Kansas Department of Agriculture
 Division of Water Resources
CHANGE: P/D WORKSHEET

RE: Field Office Application for Change
Water Right, File Nos. 968, 8210, 15366

FILE Nos. 968 & 8210 APPLICATION TO CHANGE THE POINT OF DIVERSION

RE: Applications for Change in Points of Diversion
Water Right, File Nos. 968, 8210 & 15366

Data Set: C:\Users\trevora\Documents\2023_moves\968_8210_15366\968 Current.aqt
 Date: 01/24/23 Time: 16:26:44

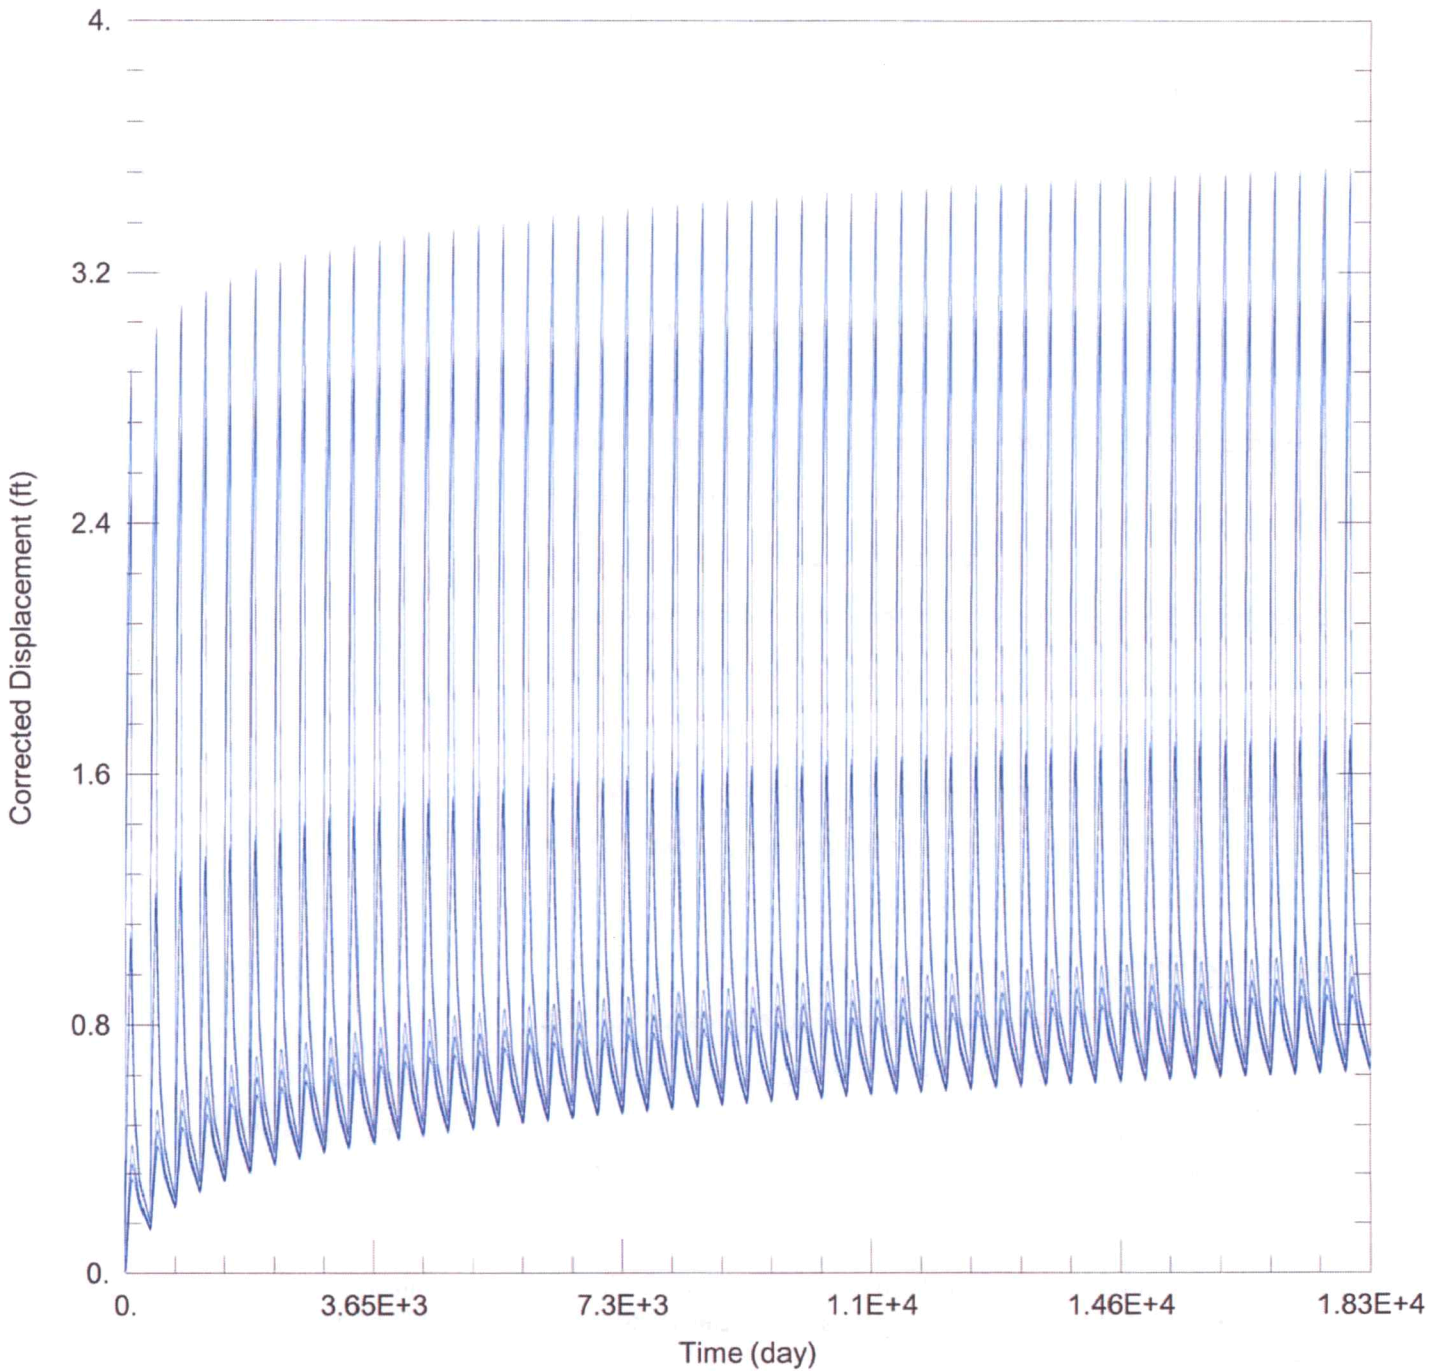
10889 & 24931: Drawdown from current location = 0.95 ft
Drawdown from proposed location = 3.24 ft
Net drawdown = **2.3 ft**

17498: Drawdown from current location = 1.72 ft
Drawdown from proposed location = 4.07 ft
Net drawdown = **2.3 ft**

Domestic 10-33-38: Drawdown from current location = 0.90 ft
Drawdown from proposed location = 3.09 ft
Net drawdown = **2.2 ft**

Domestic 16-33-38: Drawdown from current location = 3.53 ft
Drawdown from proposed location = 3.02 ft
Net drawdown = **-0.5 ft**

Domestic 15-33-38: Drawdown from current location = 1.02 ft
Drawdown from proposed location = 3.80 ft
Net drawdown = **2.8 ft**

Domestic 21-33-38: Drawdown from current location = 3.12 ft
Drawdown from proposed location = 2.90 ft
Net drawdown = **-0.2 ft**

Net drawdown does not exceed the drawdown allowance of 4.0 ft for any well within 1 mile of the proposed location. Therefore, critical well analysis is not necessary.

The proposed move is likely to create minimal effects on neighboring wells and appears unlikely to cause impairment. Any concerned neighbors should contact GMD3 at (620) 275-7147 or the Division of Water Resources at (620) 276-2901.
